**Independent Advisory Panel to IDB Invest**

**IAP Report N°3, October 2019**

**Ituango Hydropower Project**

Figure 2 – Underground complex, transformer cavern.

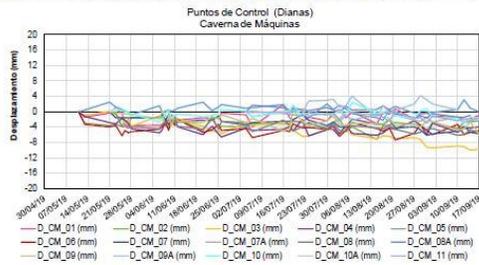
Figures 3-6 showed above, selected from the monitoring of the caverns since May 2019 and September 2019, no deformations are measured, or those are in the frame of the accuracy of the instrument of measurement. The rock mass is not overall distressed, no loosened, showing no indications of an overall stability problem. The geodetic measurements do not show any closure of the opening. This does not mean that the additional reinforcement of the caverns has to be neglected (rf. IAP report of March 2019).

Figure 26 – Section of the alternative design.

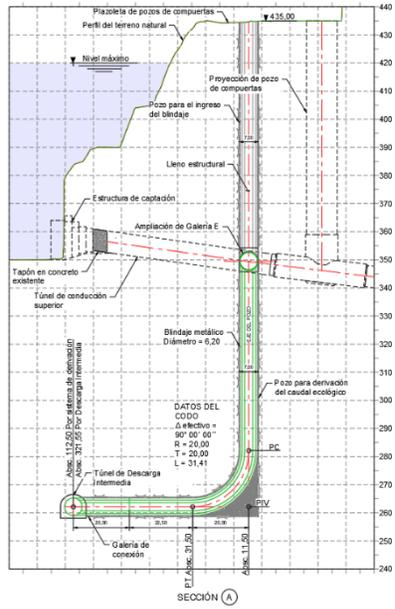
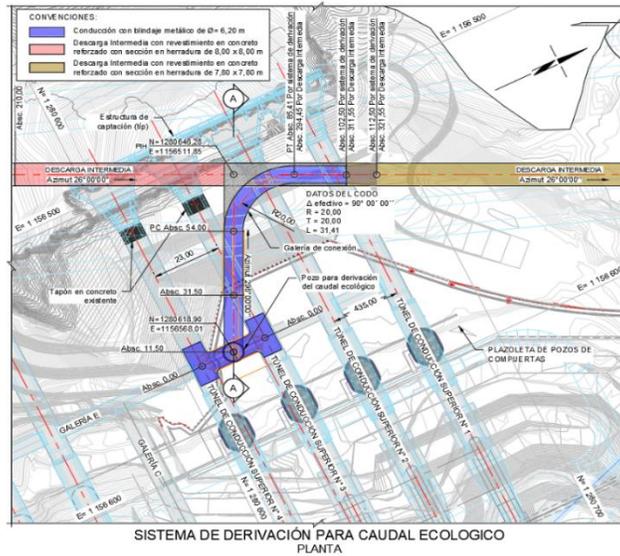
A major design change was recently put forward. It foresees the abandonment of the original portal and the placement of the IDG intake at higher elevation, feed by the power intake 3 and 4, upstream of the gates but downstream of the plugs, through a vertical shaft designed for 450 m<sup>3</sup>/s and connected to the IDG downstream of its current plug.

This option is less risky in terms of schedule and methodology and less costly.

However, it would definitively forego the possibility of controlling the reservoir level below, say, 370 / 350 m a.s.l. The only means to lower reservoir level would be through the turbines, which cannot be relied on, in the long term, and in the occurrence of emergency situations (e.g. strong earthquake).

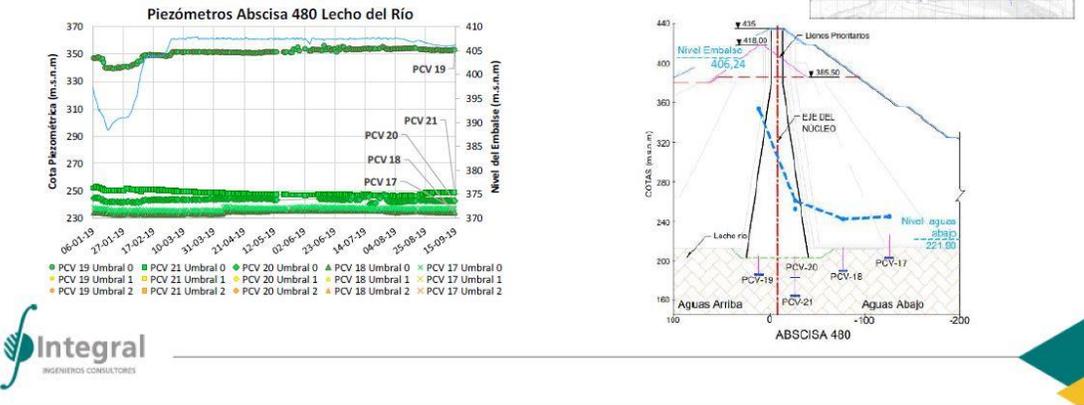
Figure 29 – Piezometric profile at the left side of the dam and its foundation, and its evolution with time. Good behavior of the core of the dam. Piezometric heads downstream of the grout curtain, higher than expected. Leakages are recorded in the inspection gallery, left side. Although no high (170 l/sec), additional grouting in this area is foreseen.
